The Road to Licensure and Beyond

The Road to Licensure and Beyond
Sample Graphic Vignette Problems

Evaluating Your Sample Solutions

Sample Problem 2
Solution 6 of 12

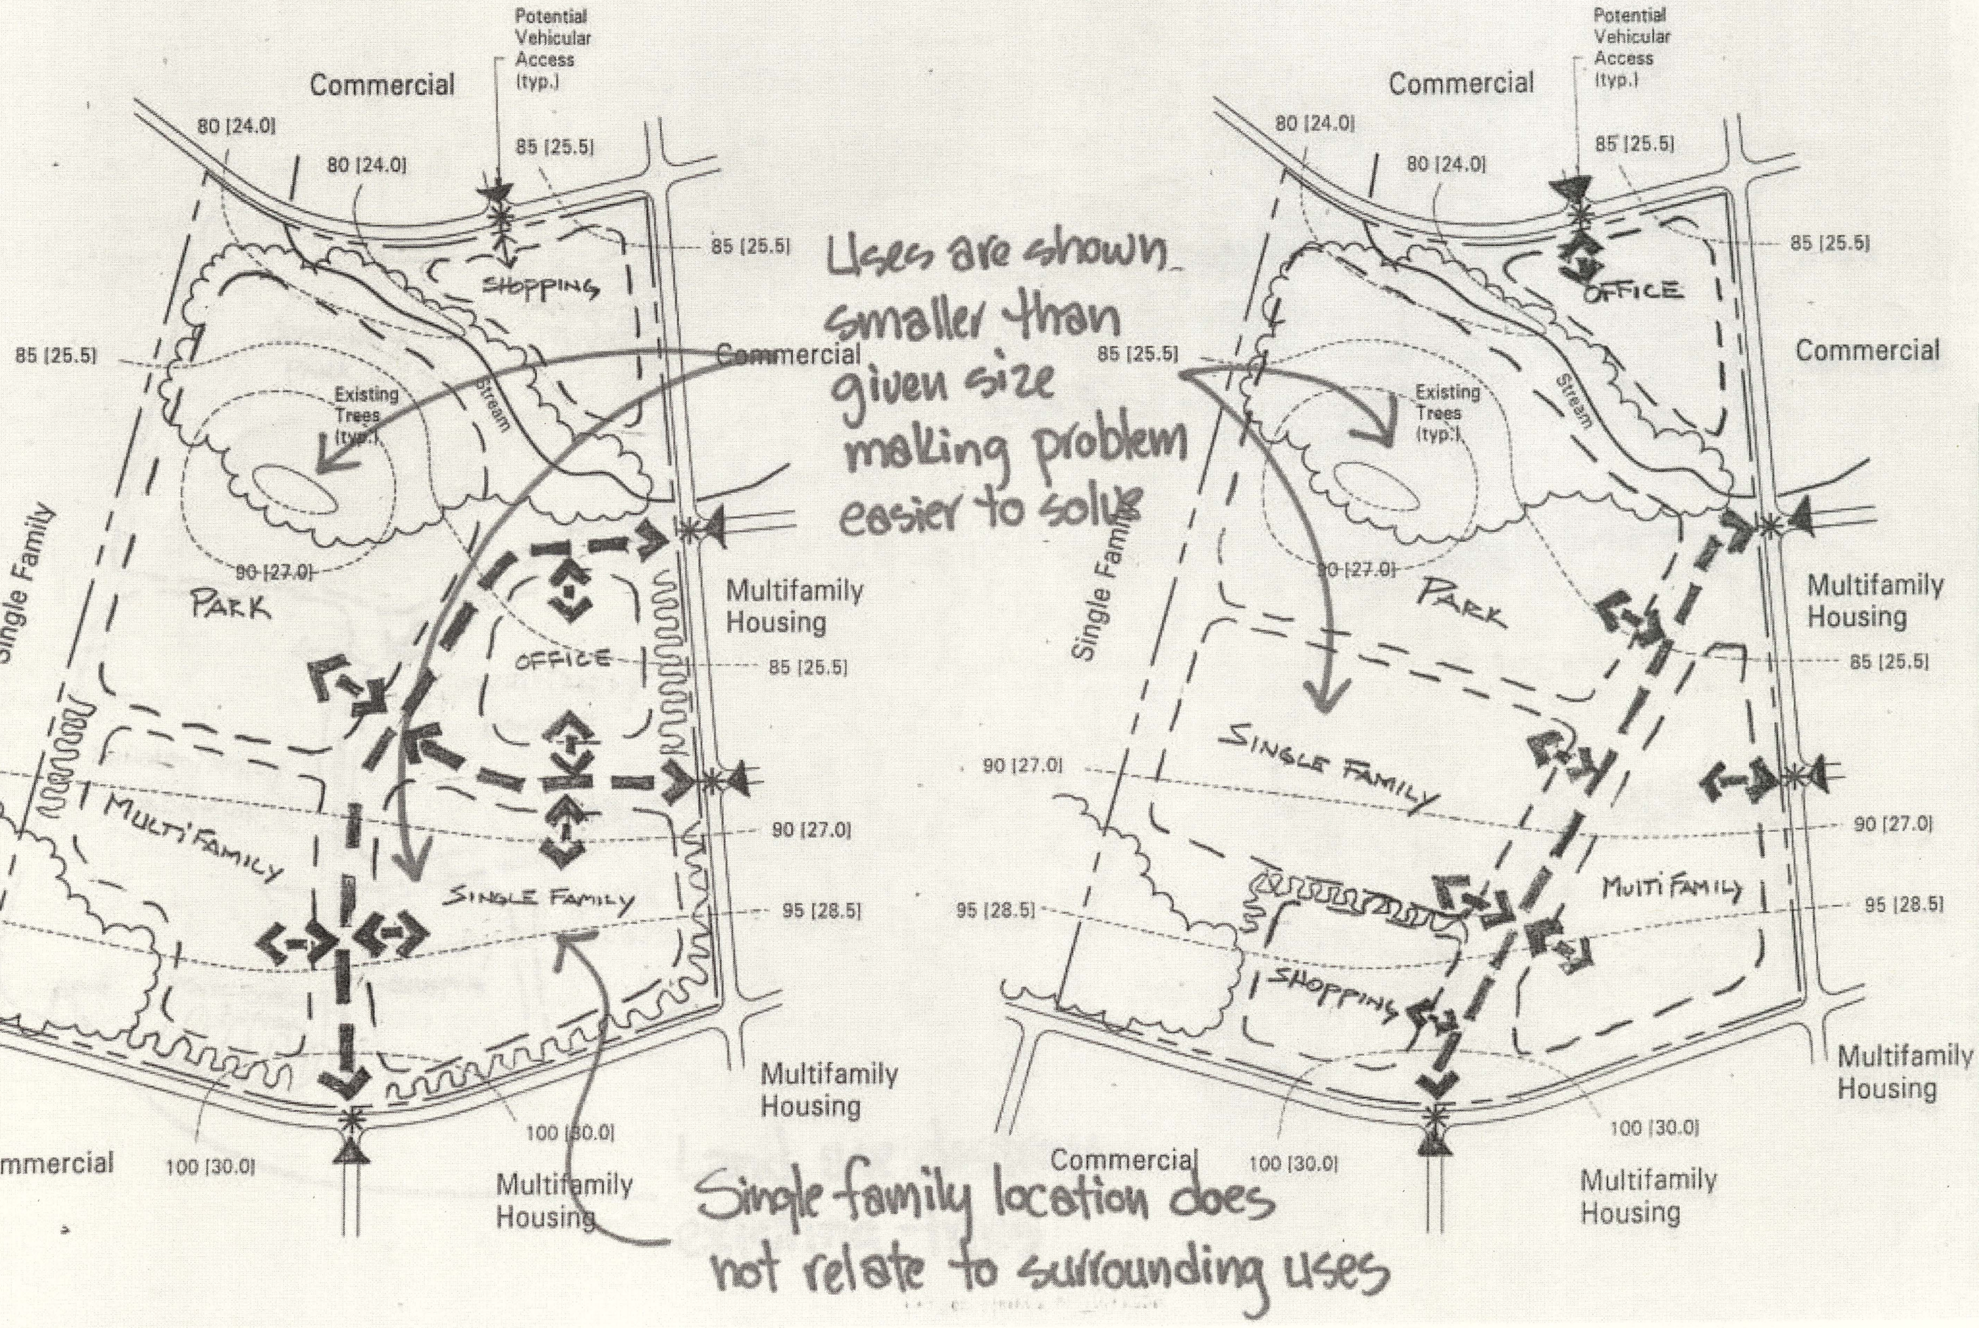
Uses are shown smaller than given size making problem easier to solve

Single family location does not relate to surrounding uses

Sample Problem 2
Solution 8 of 12

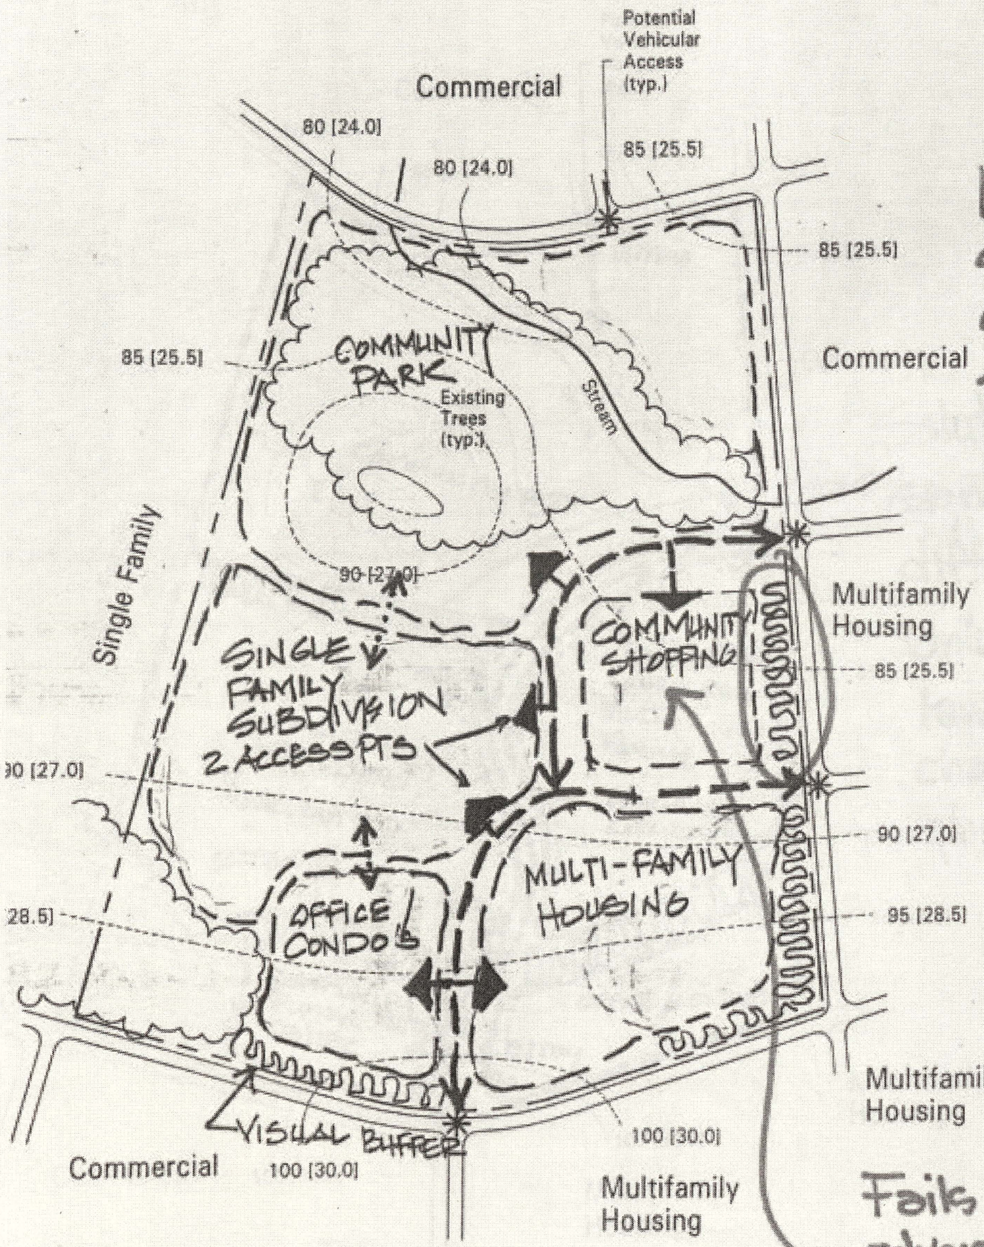
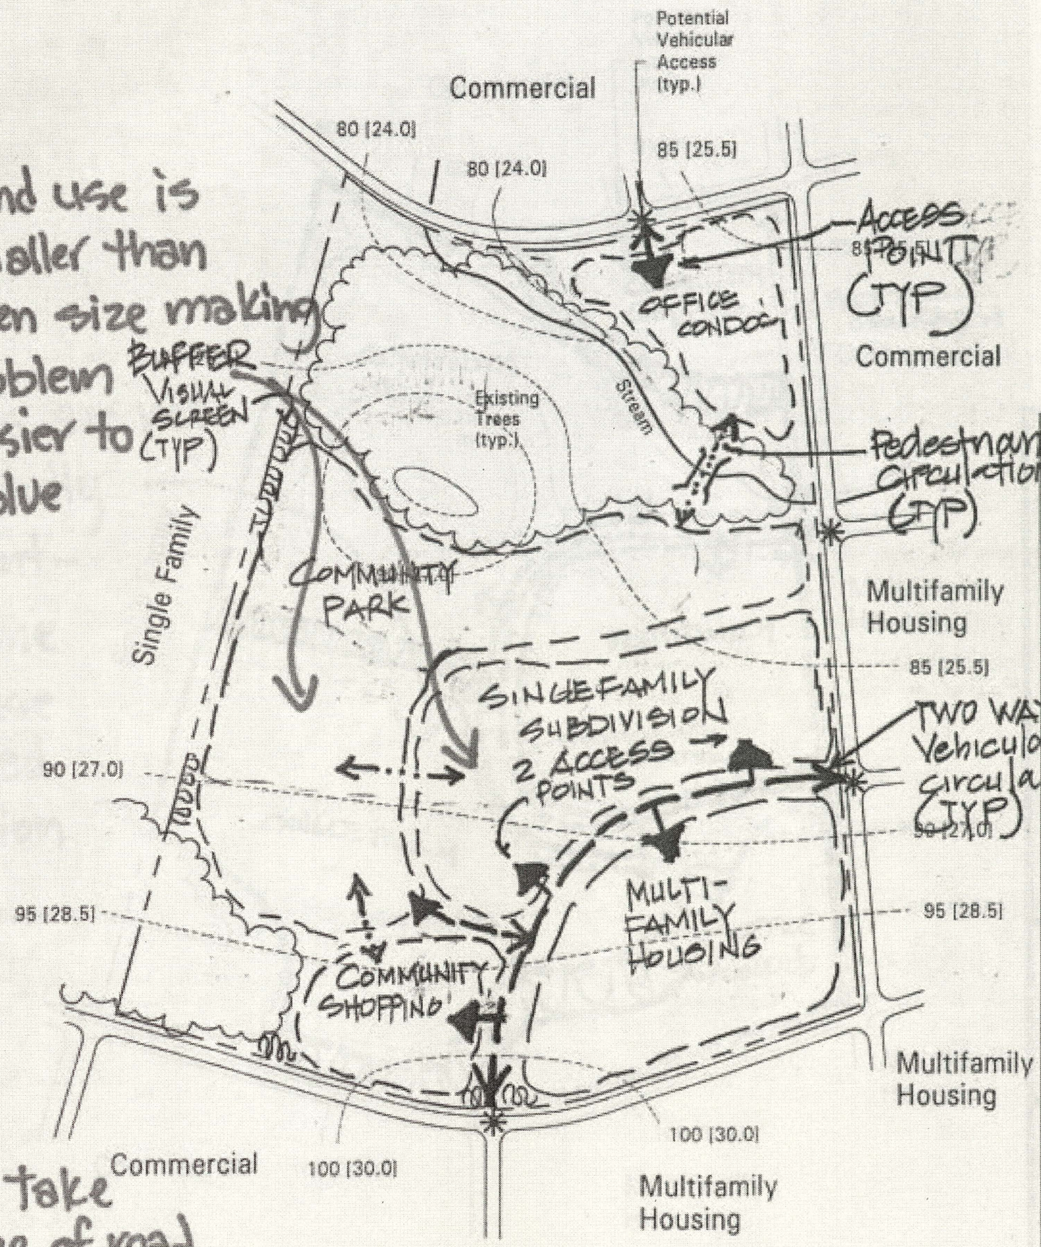
Land use is smaller than given size making problem easier to solve

Fails to take advantage of road frontage

Sample Problem 2
Solution 11 of 12

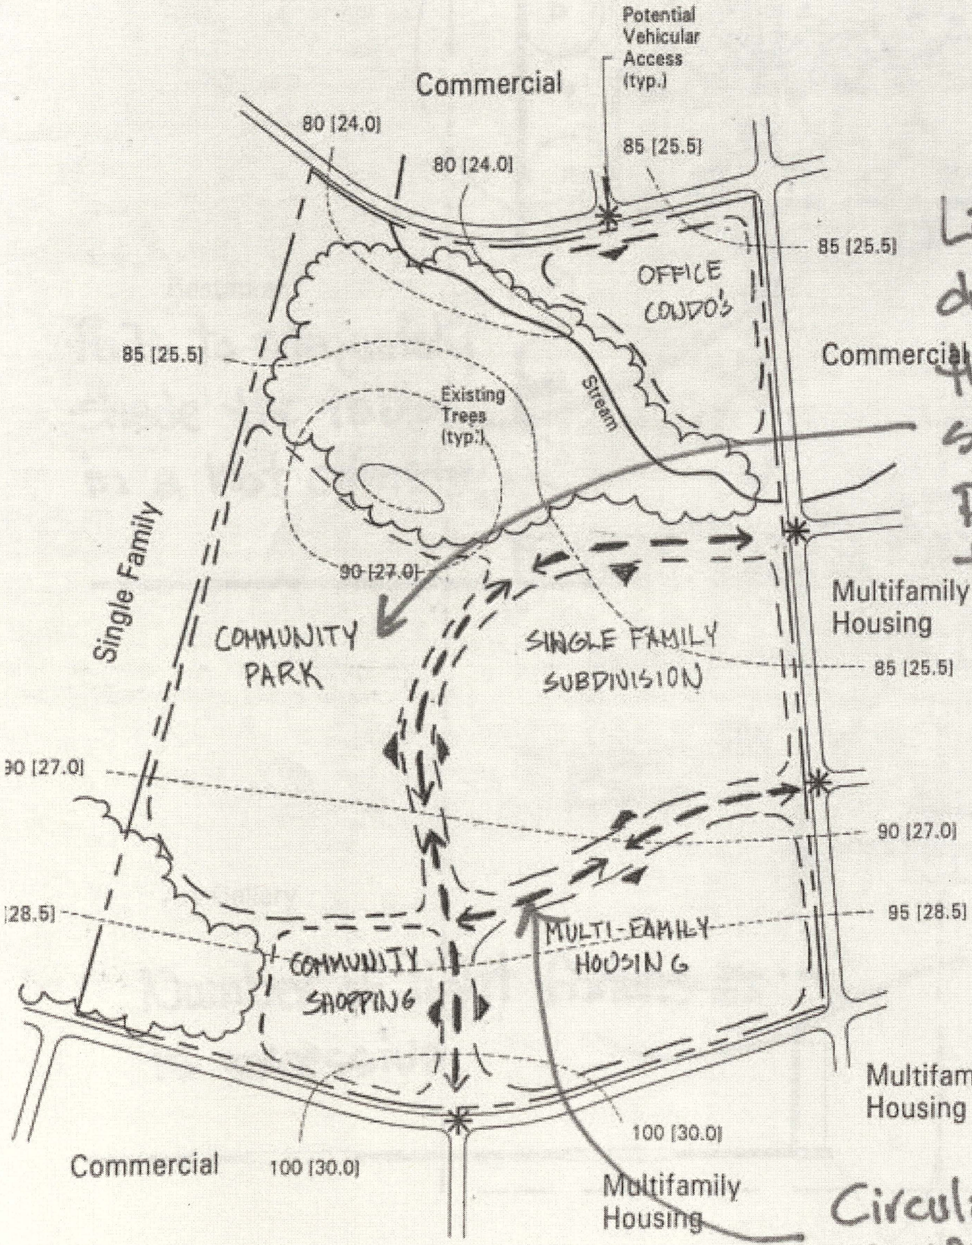
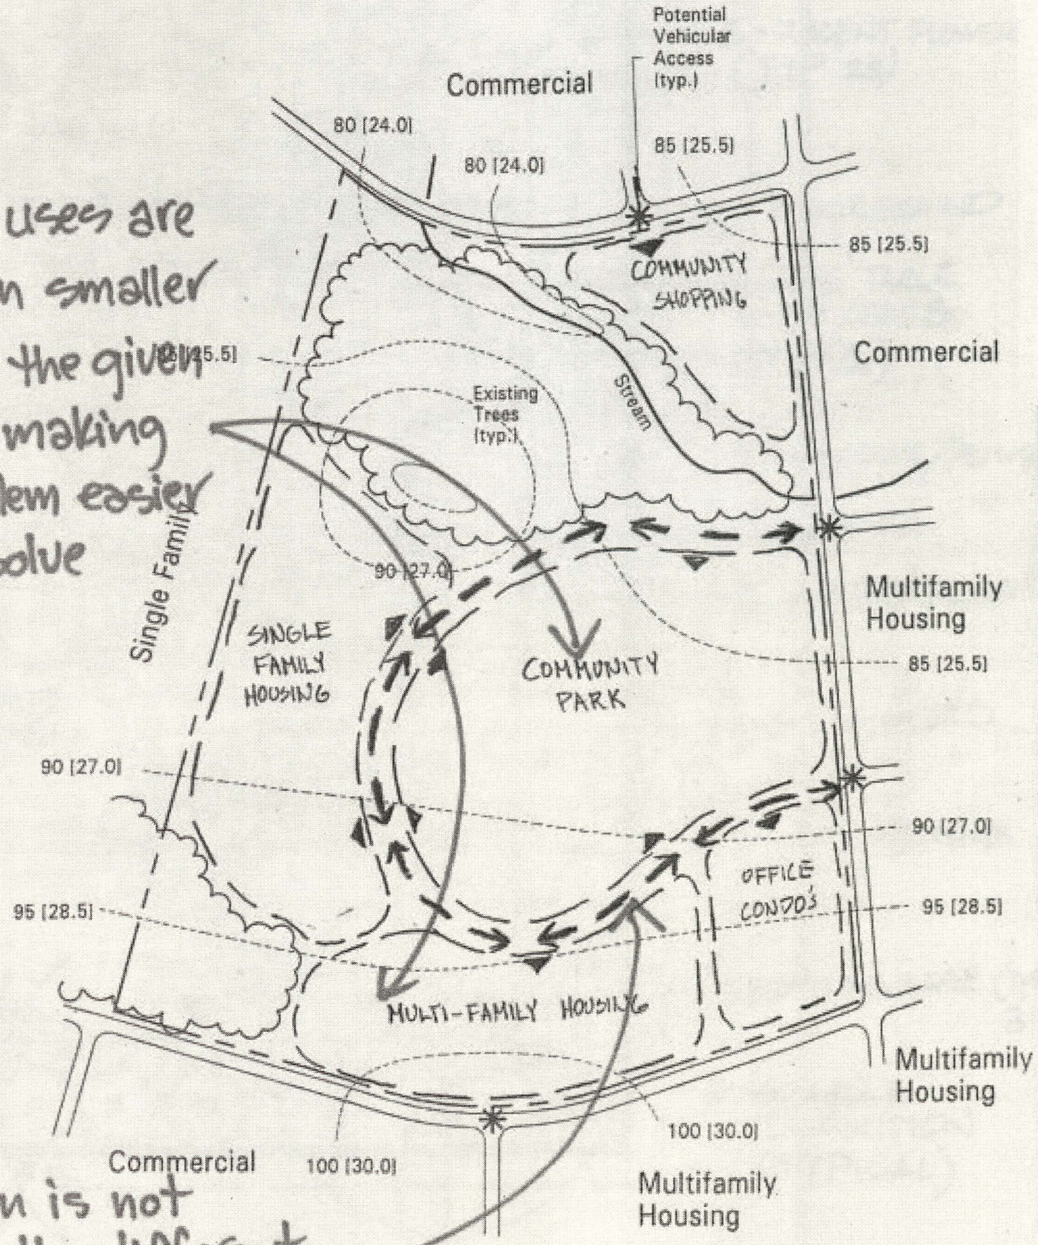
Land uses are drawn smaller than the given size making problem easier to solve

Circulation is not significantly different

Sample Problem 3
Solution 1 of 12

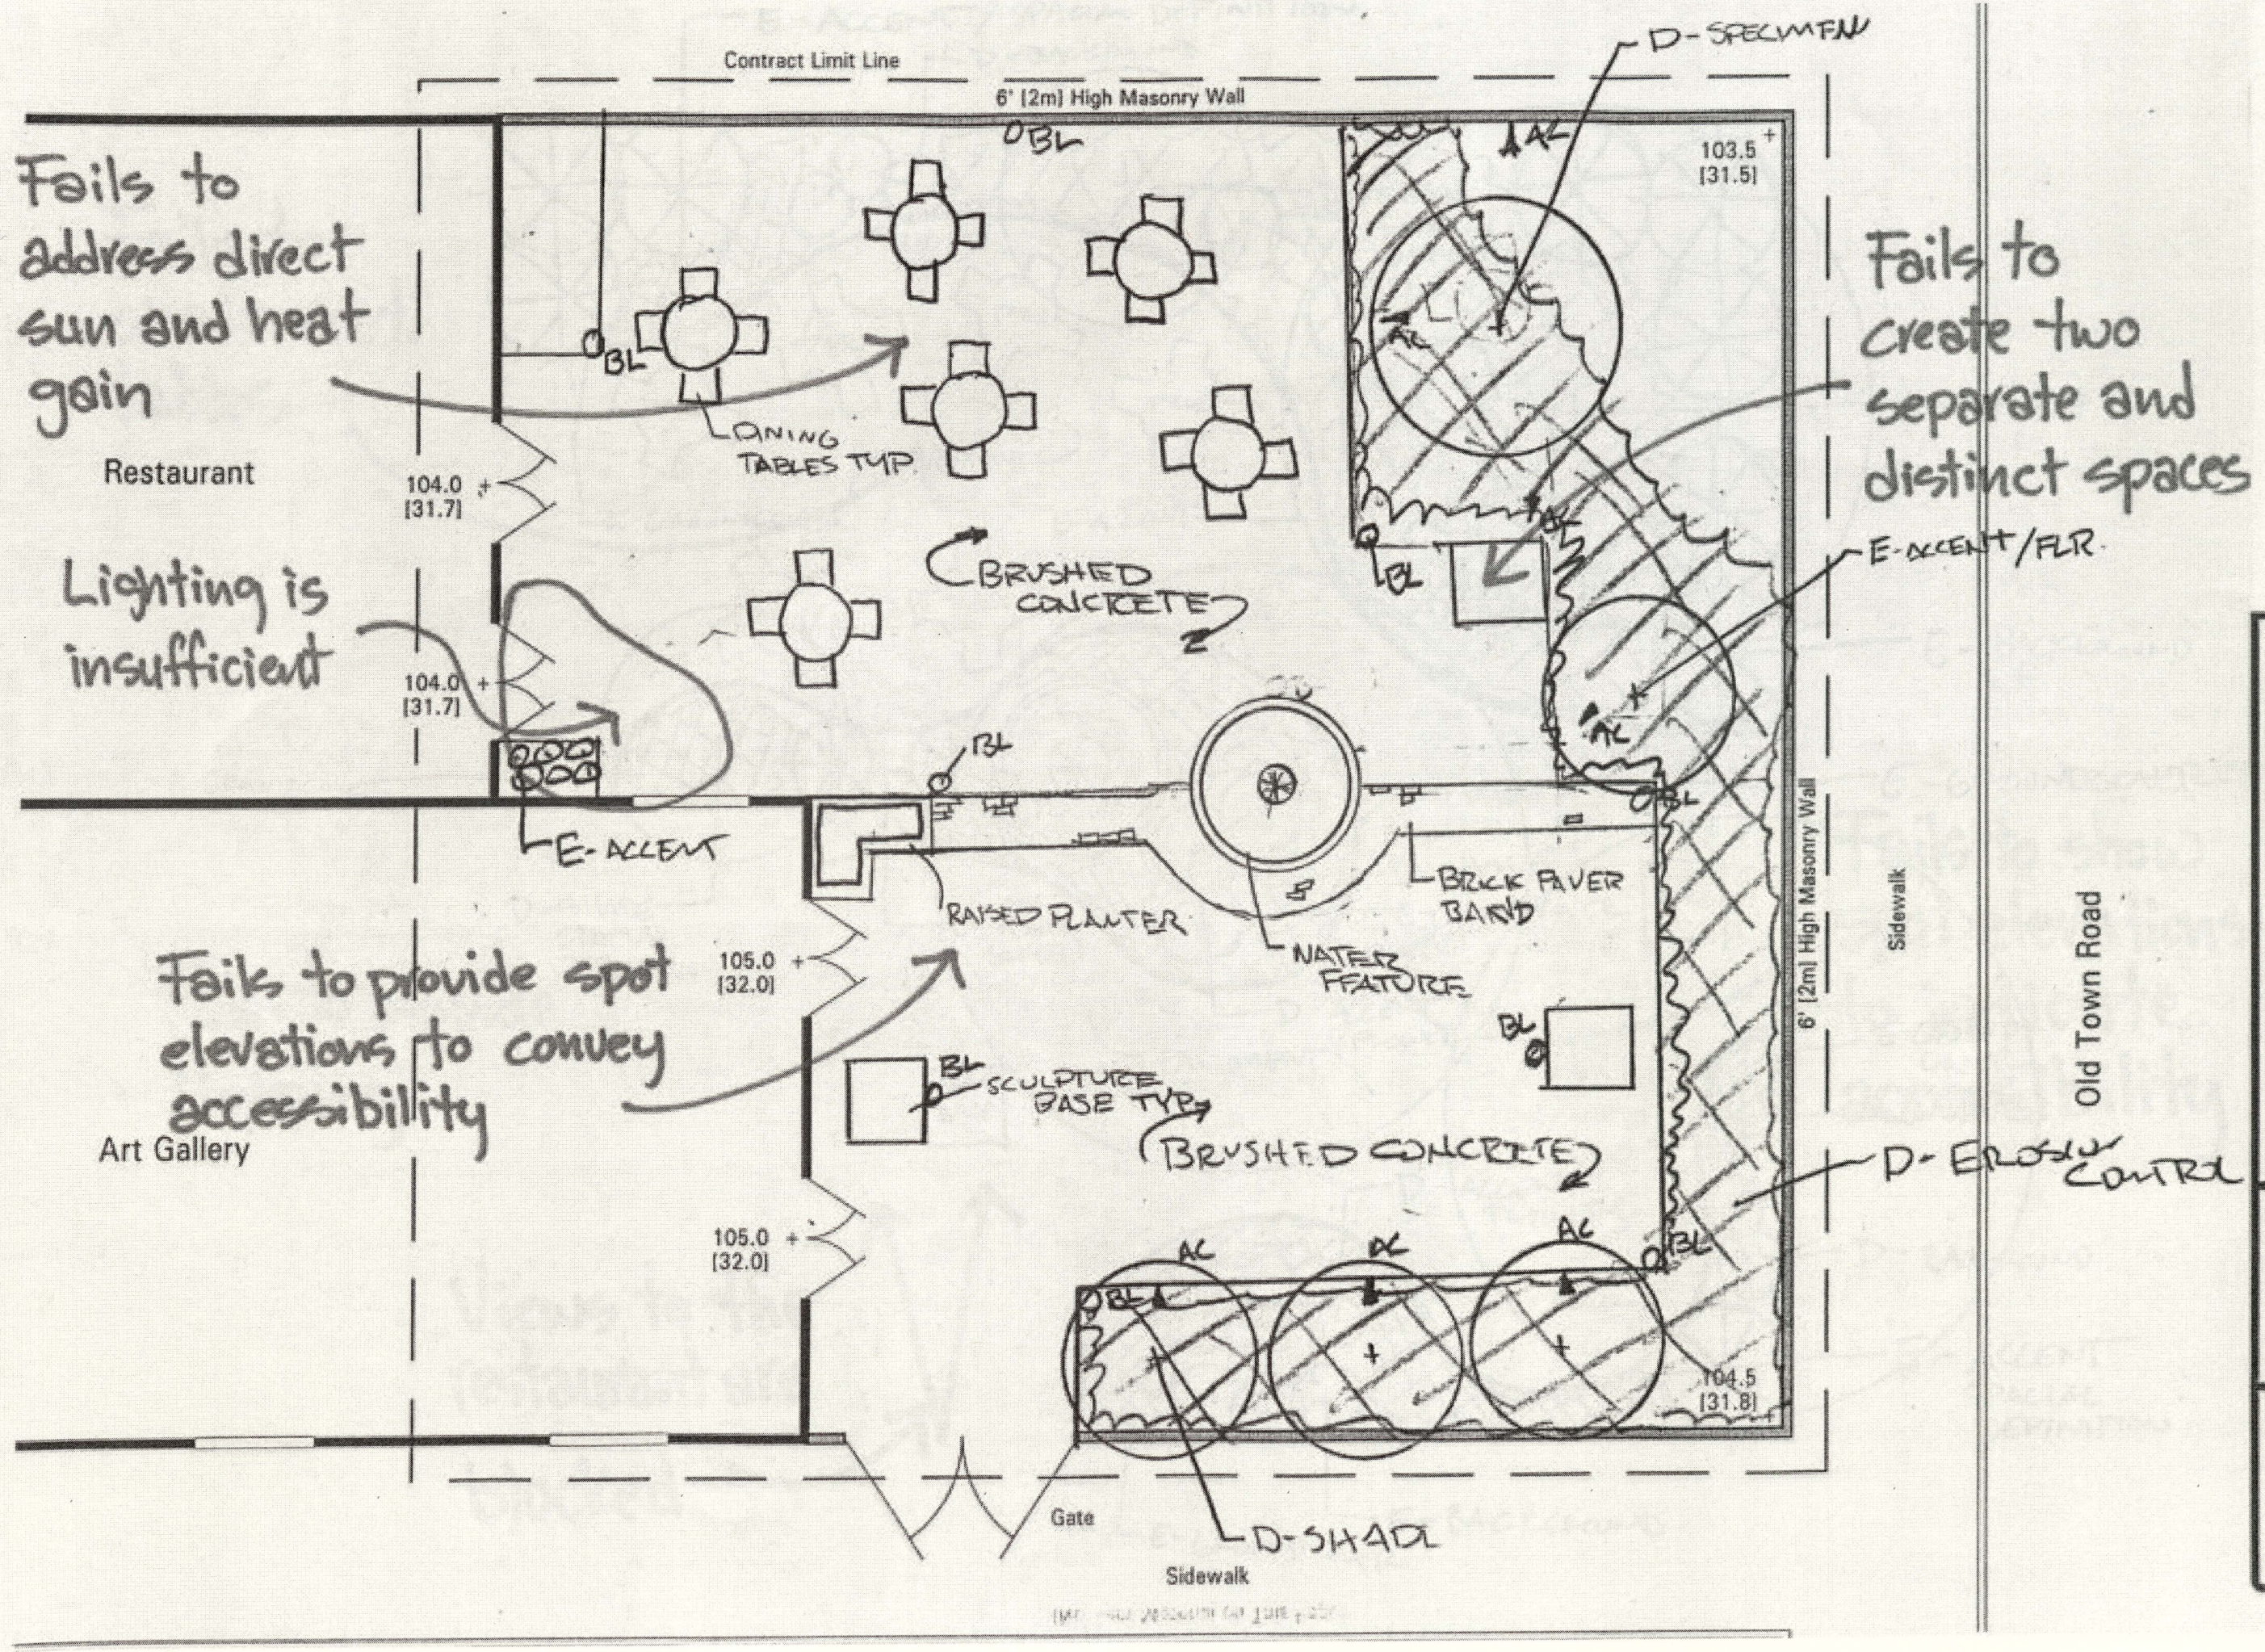
Low light fixtures in pedestrian travelways are hazardous

Fails to adequately shade the tables in a hot climate

Number of light fixtures is excessive
